SPLN22-00002 Wells Fargo/Verizon

General Land Use Plan Amendment, New Site Plan, Use Permit

3140 Washington Boulevard (Wells Fargo); 1025 N. Irving St. (Verizon).
(RPC#19004012; 19004005; 19004011; 19004008)

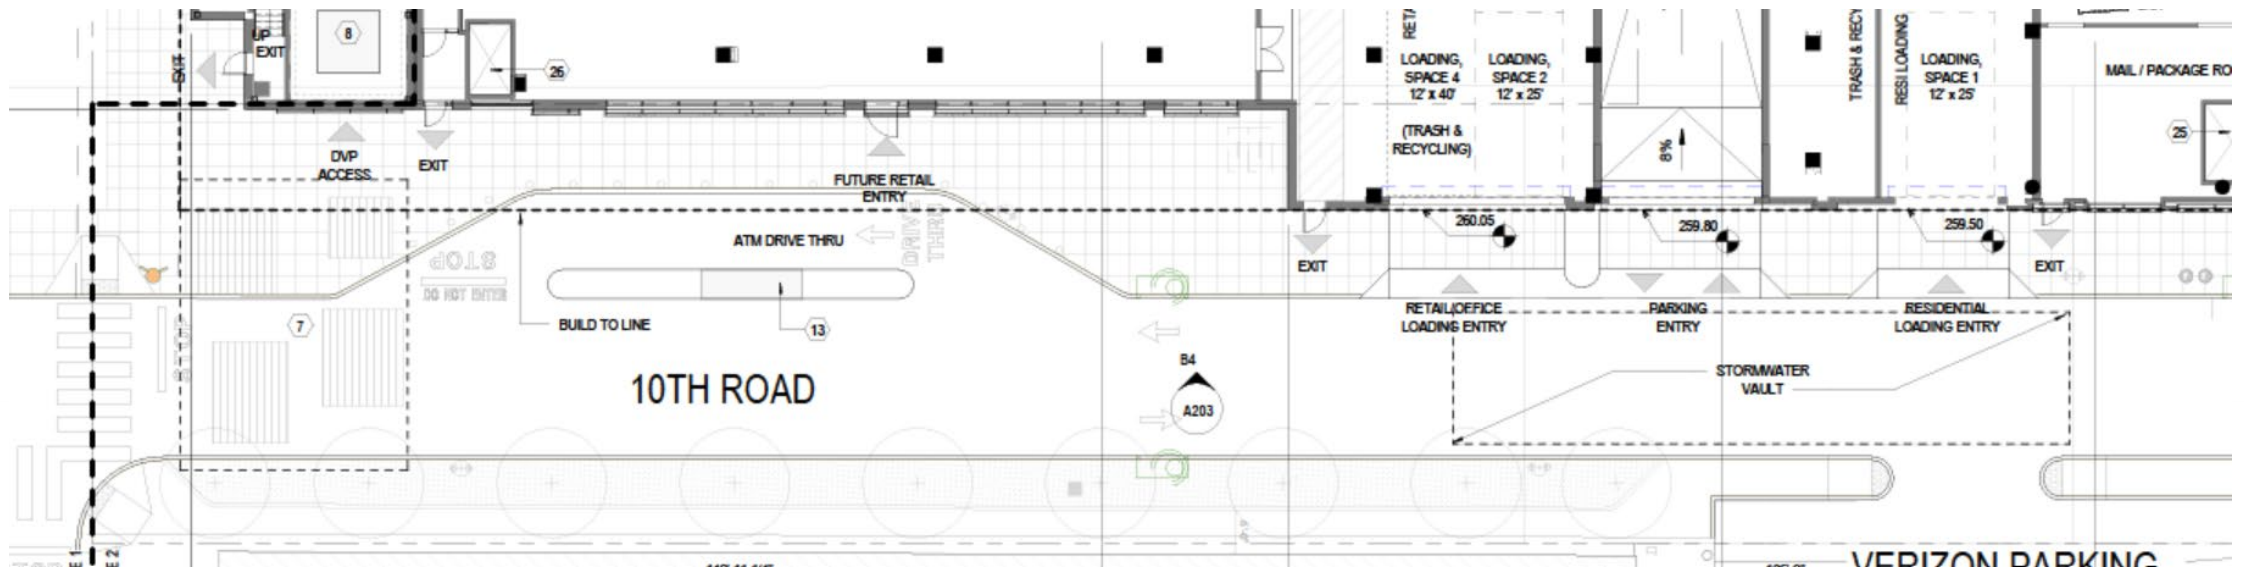
- Wells Fargo Bank wants space adjacent to public plaza in “Red” area.

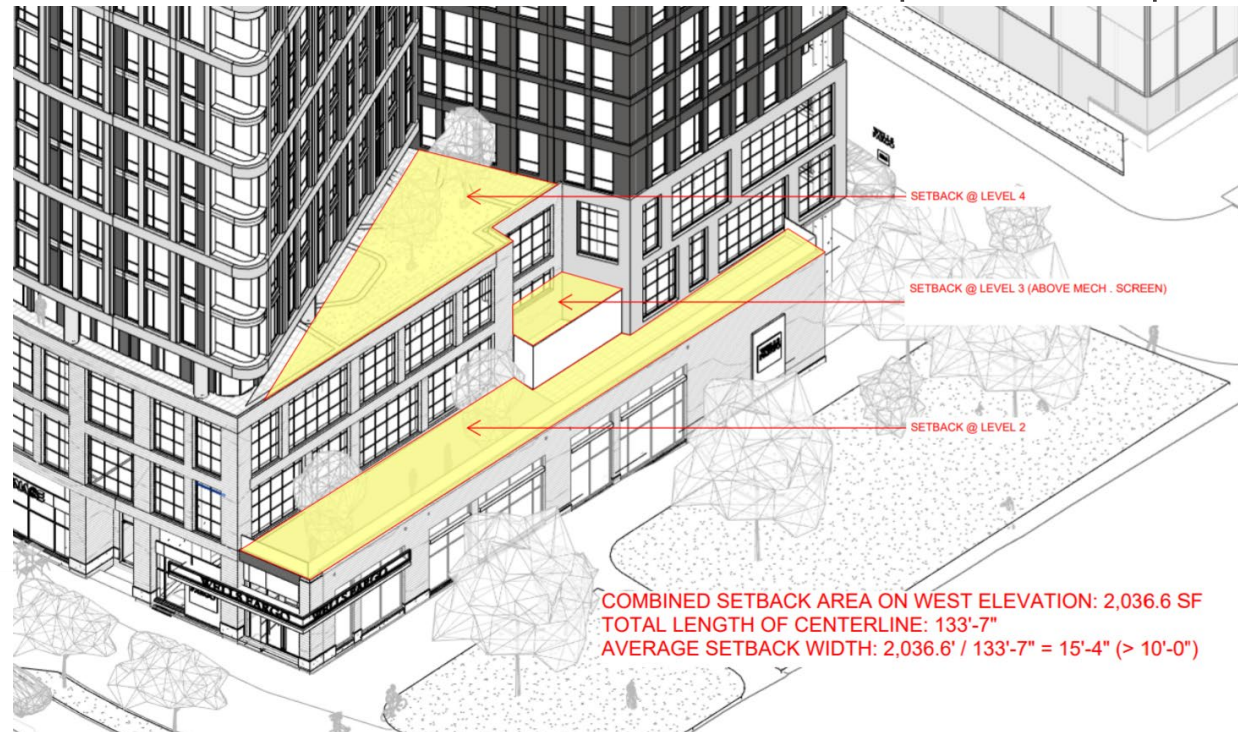
- Building meets build-to lines.
- Staff believes proposed sculpting, style and use of material to break down mass meet good design practice; with some issues of detail at ground level related to bank and drive through use.

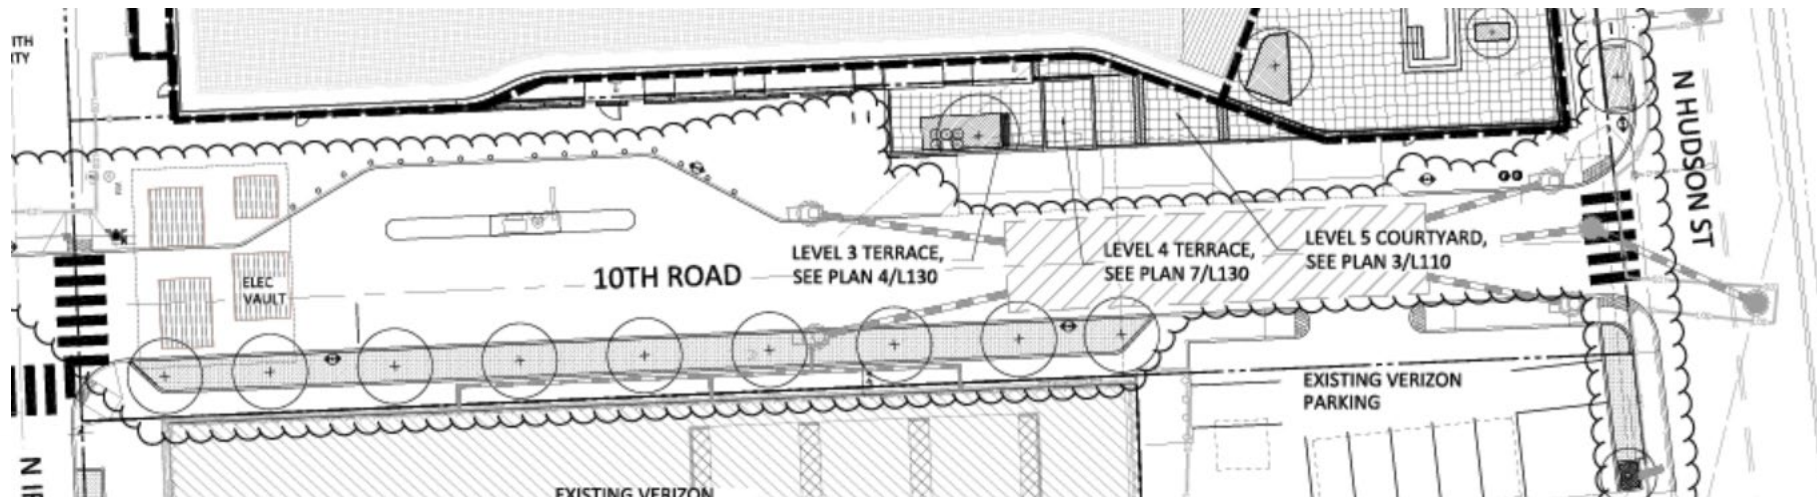
- Developer provides, on their property, adjacent to future Plaza, 13-14' of space—can developer do more on the space under their control on Irving Street

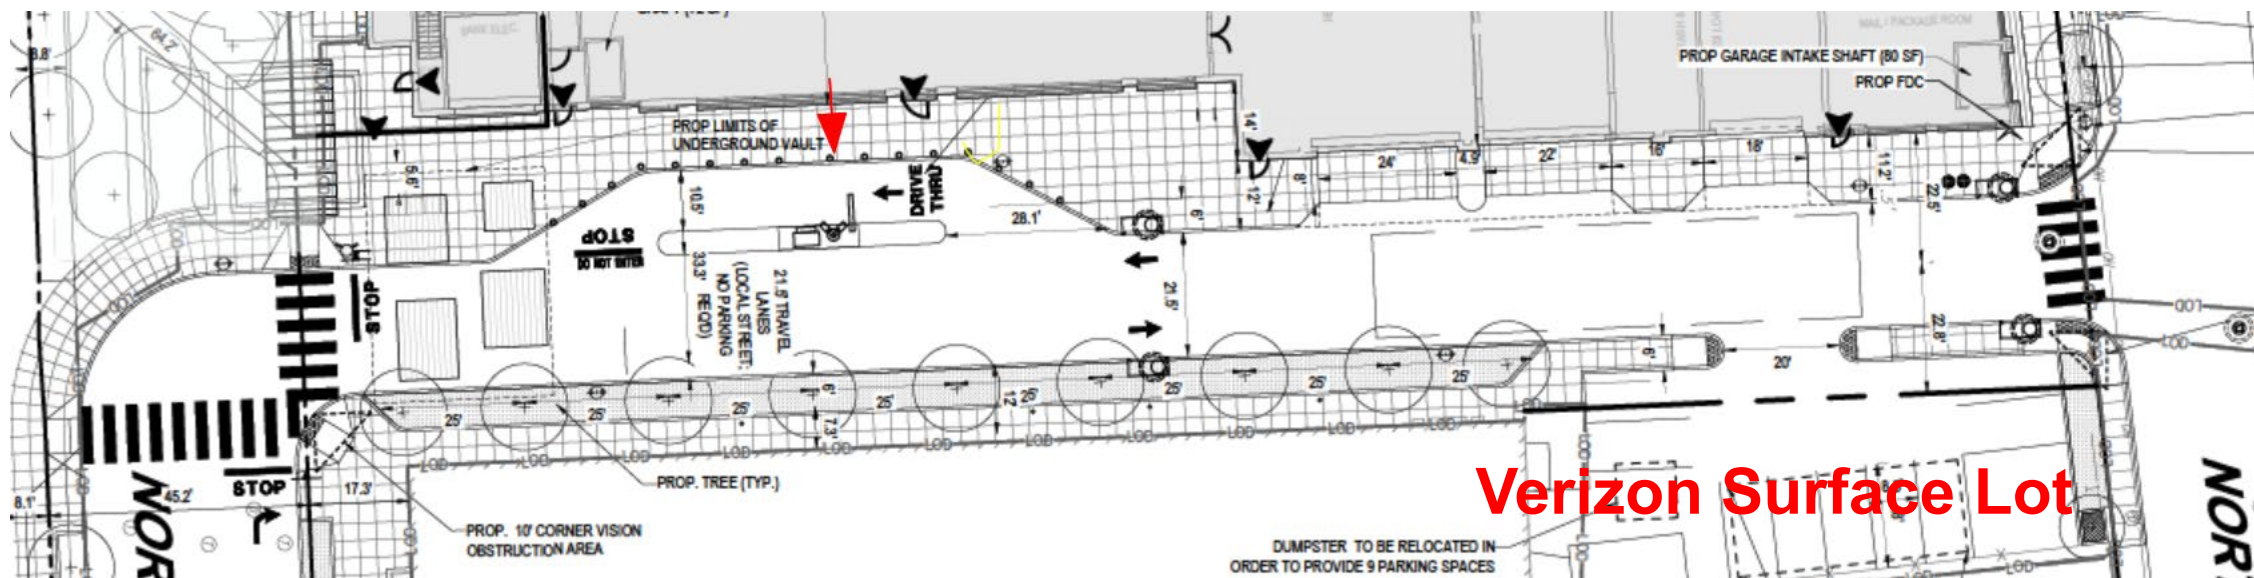
- .6 residential parking spaces provided per unit, (complaint with Multifamily Guidelines); 11 visitor spaces provided.
 - 16% compact requested
 - Verizon retains 7-9 parking spaces in a surface lot (few employees work on site)
 - Office Parking will be analyzed by staff in light of the Office Parking Policy, location, and mixed-use of the building
- Loading modification requested for
 - 1 residential loading
 - Two of the remaining loading spaces are tandem
 - Verizon retains existing loading space on Hudson Street
